LOUISIANA
POWER & LIGHT

Subject: Waterford 3 SES
Docket No. 50-382
MASONRY BLOCK WALLS

Enclosed is the additional information requested by the NRC reviewers. It is provided in the format of responses to the sixteen confirmatory items identified during the site visit. Once the material is given NRC review, LP&L is prepared to visit and discuss any further information or details on the Waterford 3 masonry walls construction.

SUBJECT: LOUISIANA POWER & LIGHT COMPANY
WATERFORD STEAM ELECTRIC STATION
1984 - 1165 MW INSTALLATION - UNIT NO. 3
FOLLOWUP ACTION PLAN FOR CLOSURE OF MASONRY
BLOCK WALLS CAT ITEM 6.2/6.3

CHKD. BY CH DATE 12-12-77 FOR-CH-891

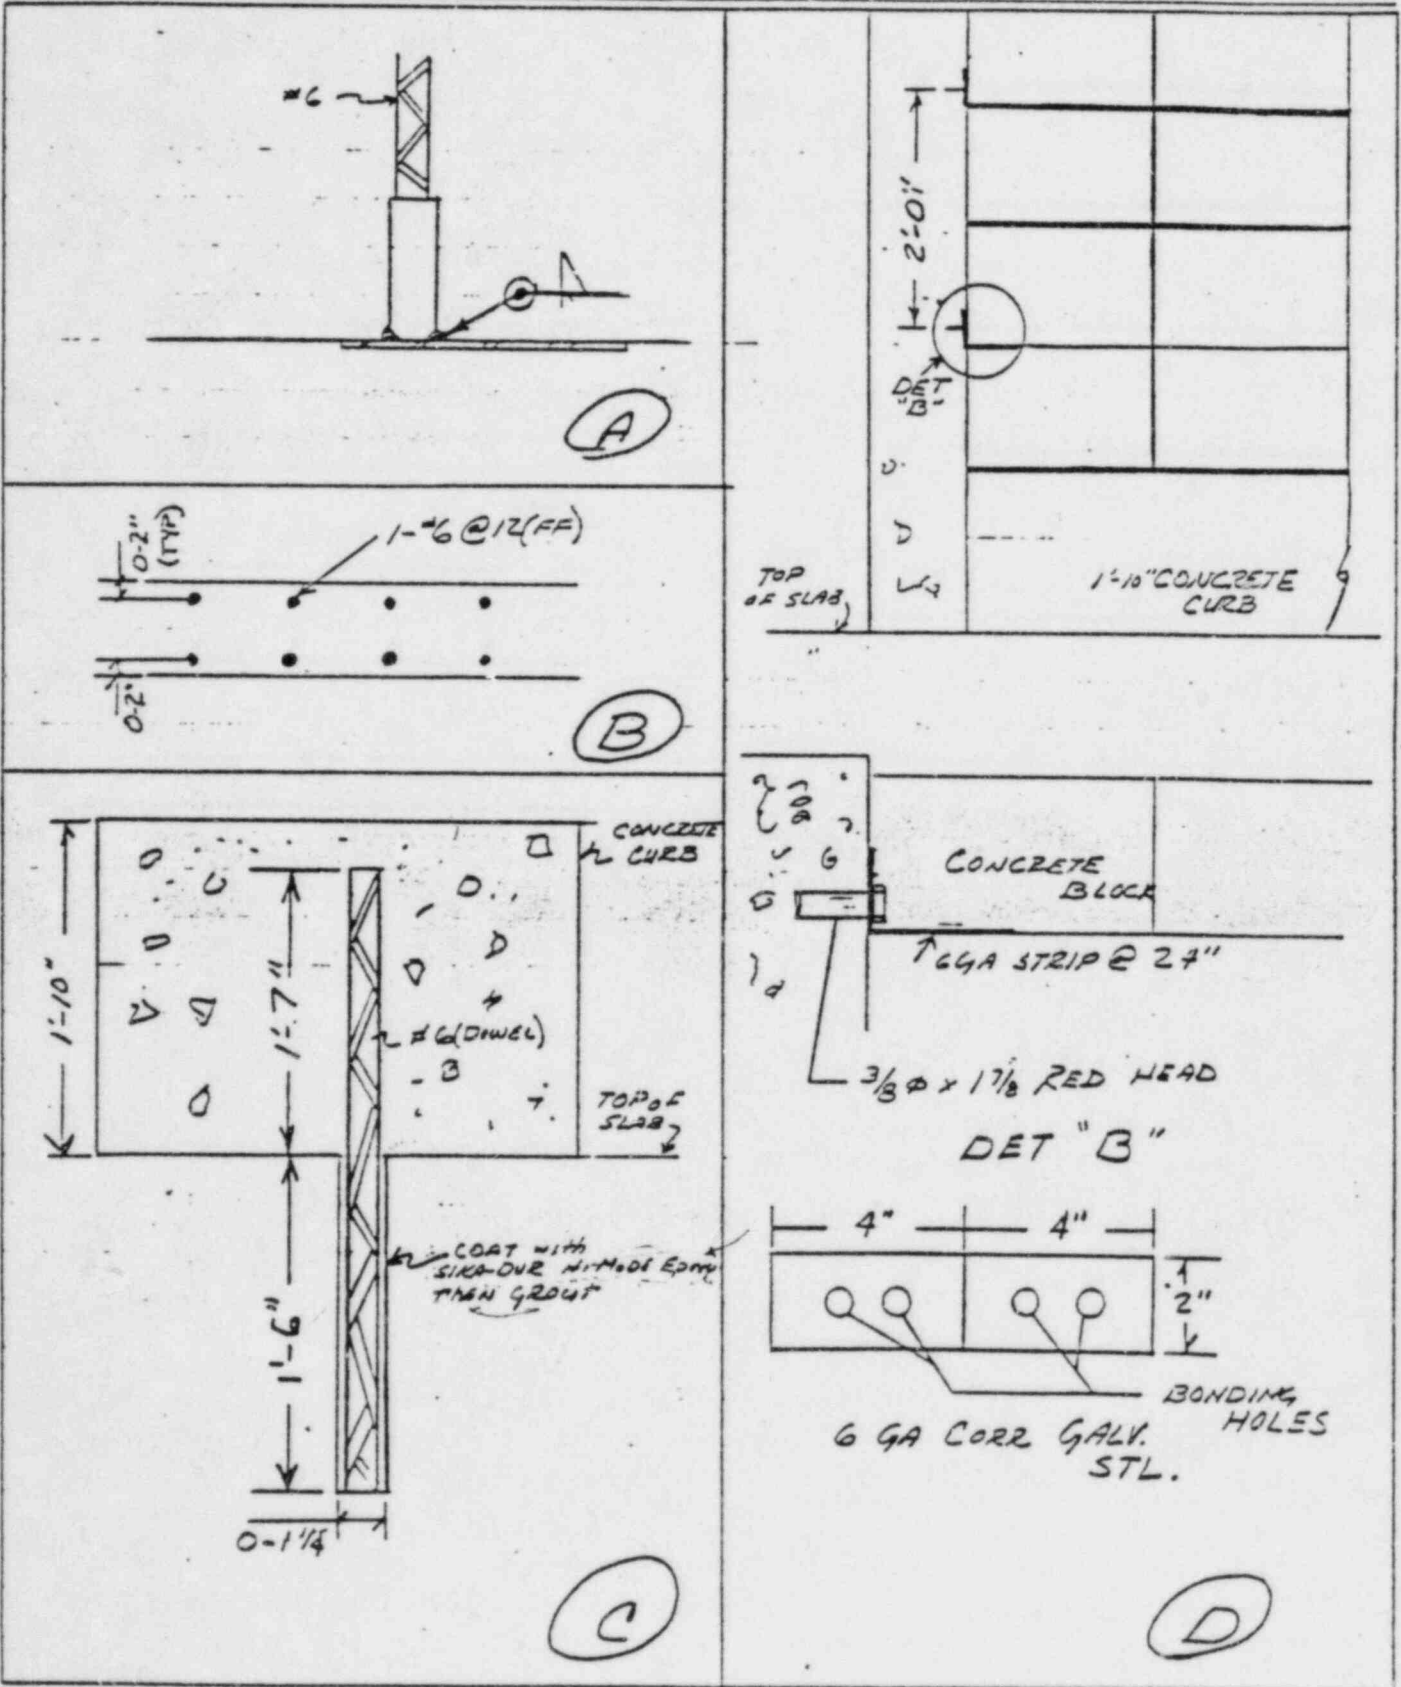
ITEM NO.	NRC REVIEW STATUS	QUESTION	RESPONSE
1.	Open	Verify structural adequacy of concrete curb used to support Hollow Block Walls. Consider shear and bending loads in analysis. Verify adequacy of lap splice detail. Verify adequacy of FCR-CH-891.	Verification of curb structural adequacy is provided in Calc. Pkg. No. 1. Package No. 1 also provides verification of lap splice details and the embedded plate detail shown in FCR-CH-891.

1. LENGTH OF $1'-7"$ FOR #6 DWLS IS ADEQUATE TO PROVIDE THE REQUIRED SPLICE LENGTH FOR CONC. BLOCK WALL REBARS, ACCORDING TO SH 3 OF 5 OF ITEM #1.
2. THE EMBEDMENT LENGTH OF $1'-6"$ INTO THE CONCRETE FLOOR IS ADEQUATE ACCORDING TO ACI 318-71 SECT 12.3.1 & 12.3.5.1 WHICH FOR #6 BARS IS $1'-6"$. SEE TABLE FOR l_d , ATTACHED.

DEPT. NO. 653CLIENT LP & LPROJECT WATERFORD #3SUBJECT CONC. BLOCK WALLS -WALL S1ITEM #5

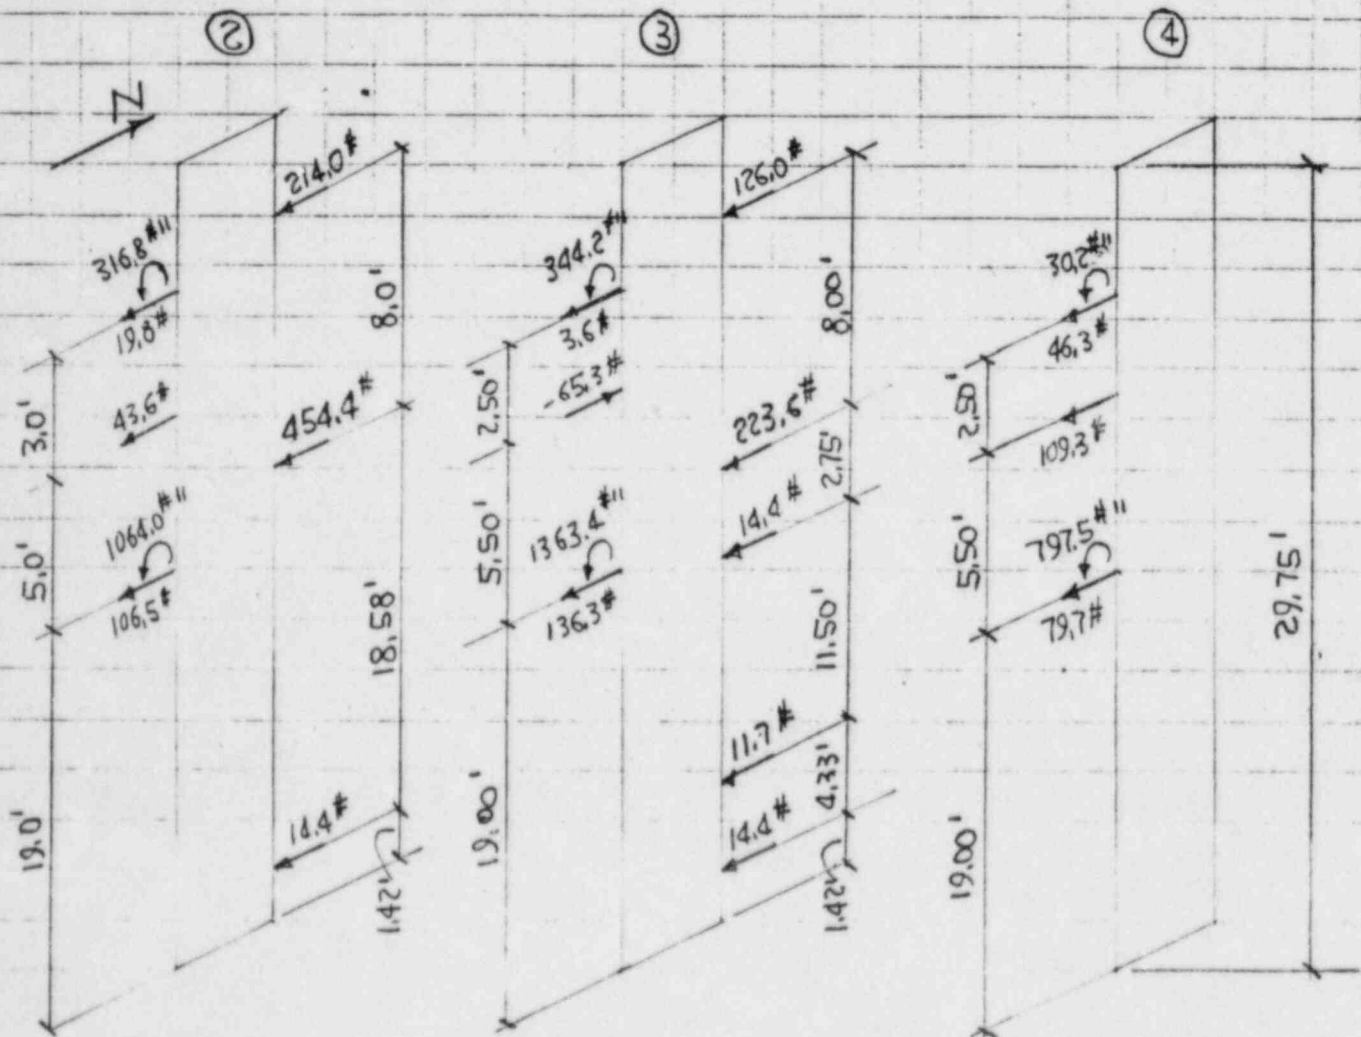
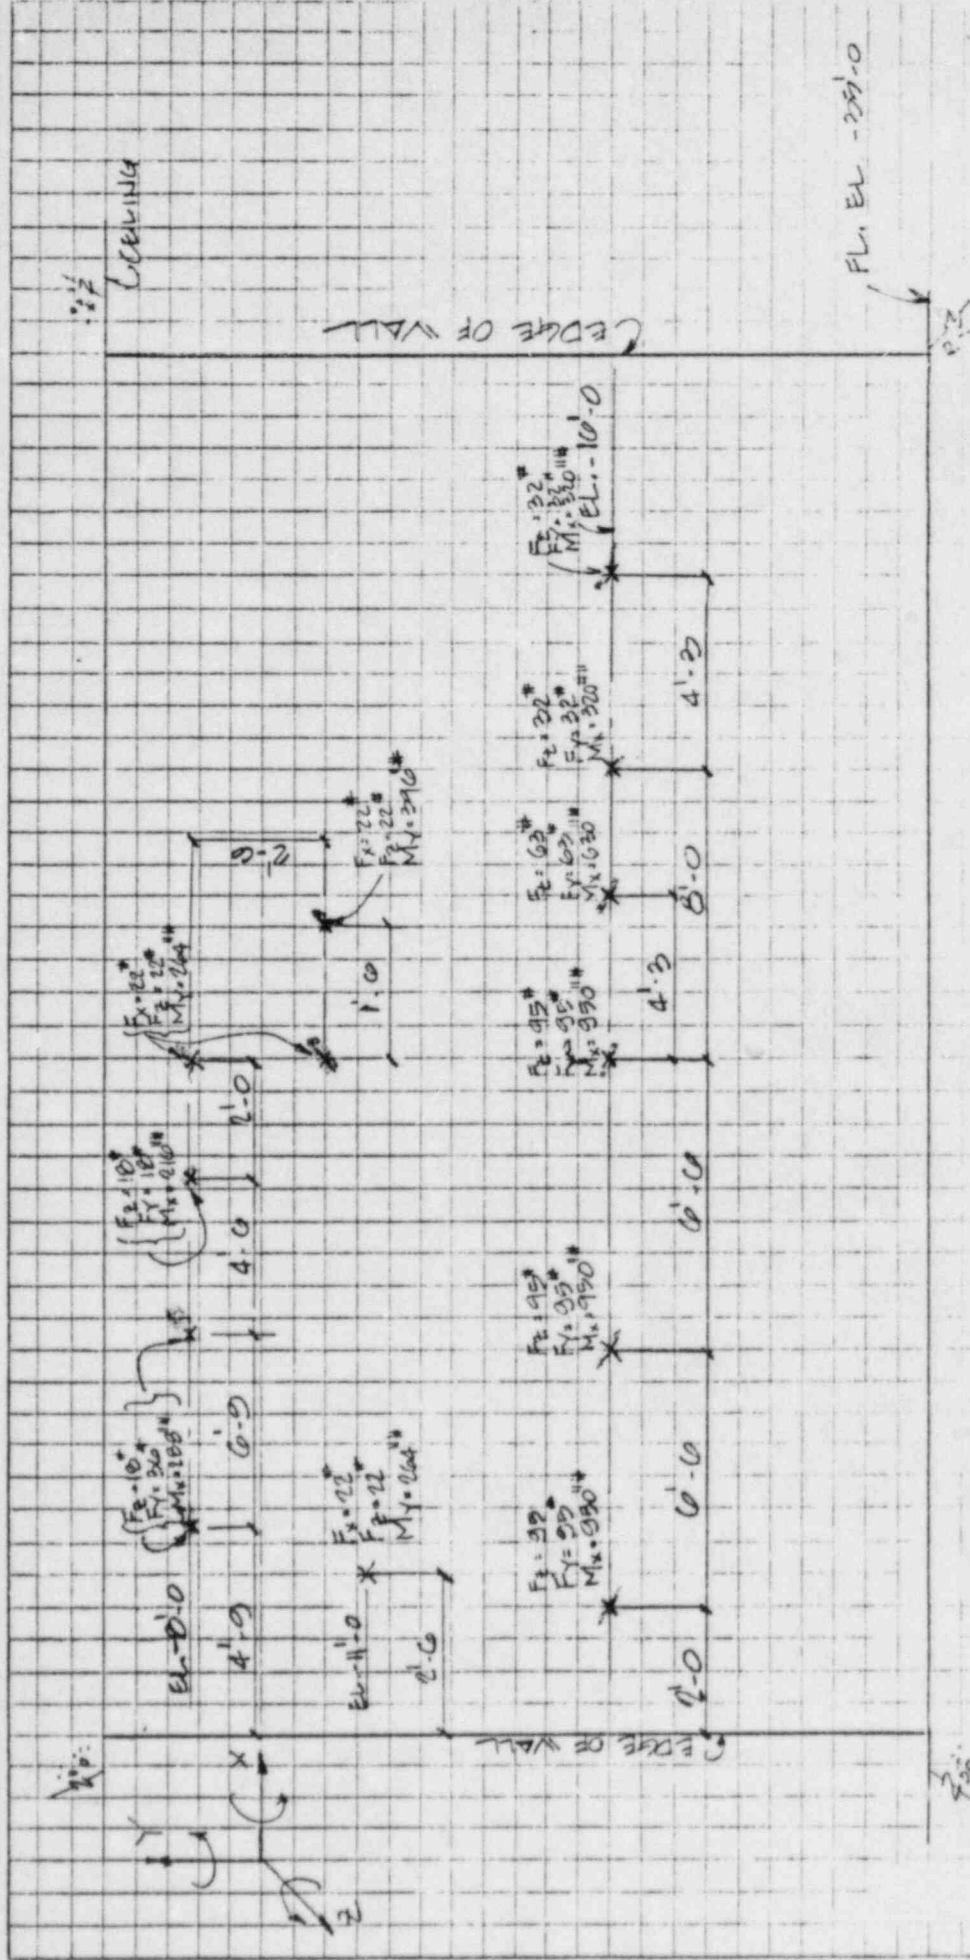
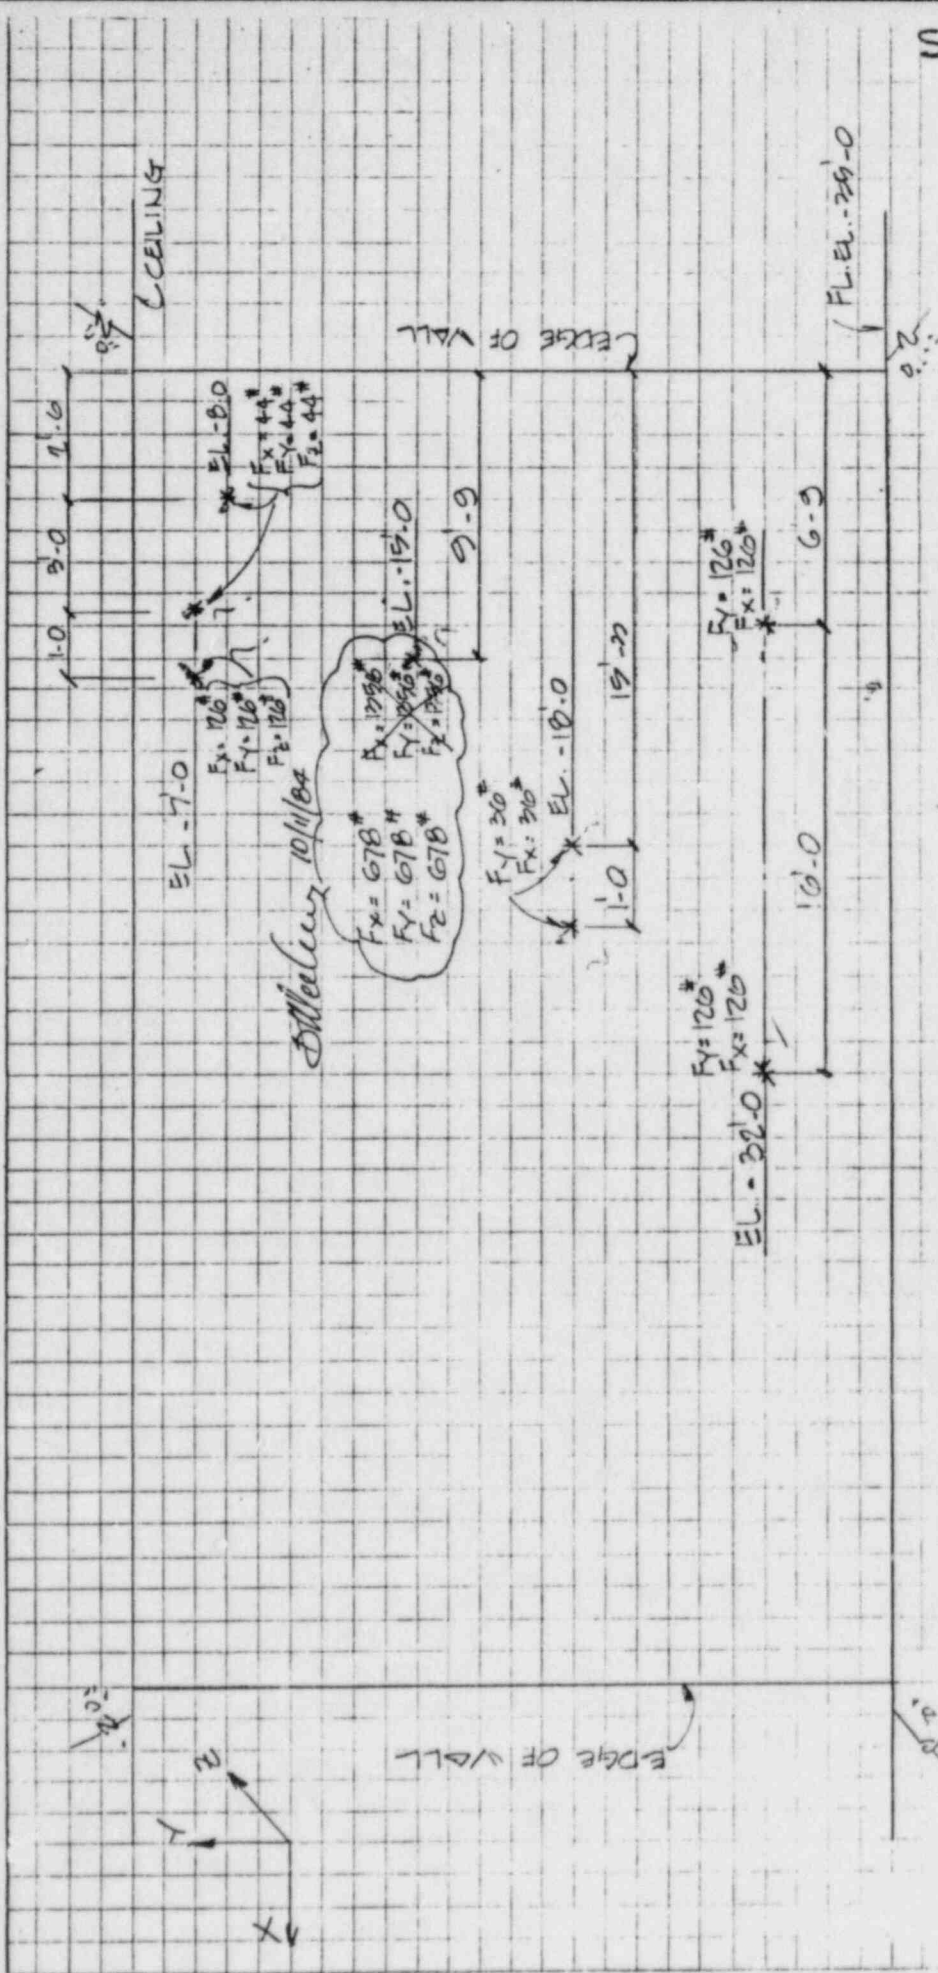
ITEM NO.	NRC REVIEW STATUS	QUESTION	RESPONSE
5.	Open	Verify the structural adequacy of Masonry Walls when miscellaneous non-seismic loads are considered. Select Walls S1, H2, H13, and W29 for this analysis.	Calculation Package No. 5 provides verification of wall S1. Verification of walls H2, H13 & W29 will be provided by 10/8/84.

NOTE: LATERAL SUPPORTS ② & ③ ARE THE MOST LOADED. A CLOSE INSPECTION OF THE LOADS SHOW THAT SUPPORT ② IS THE CRITICAL ONE THEREFORE THIS SUPPT. IS ANALYSED.

6. - BASED ON THESE CALCULATIONS, WALL S1 IS STRUCTURALLY ADEQUATE AS BUILT.
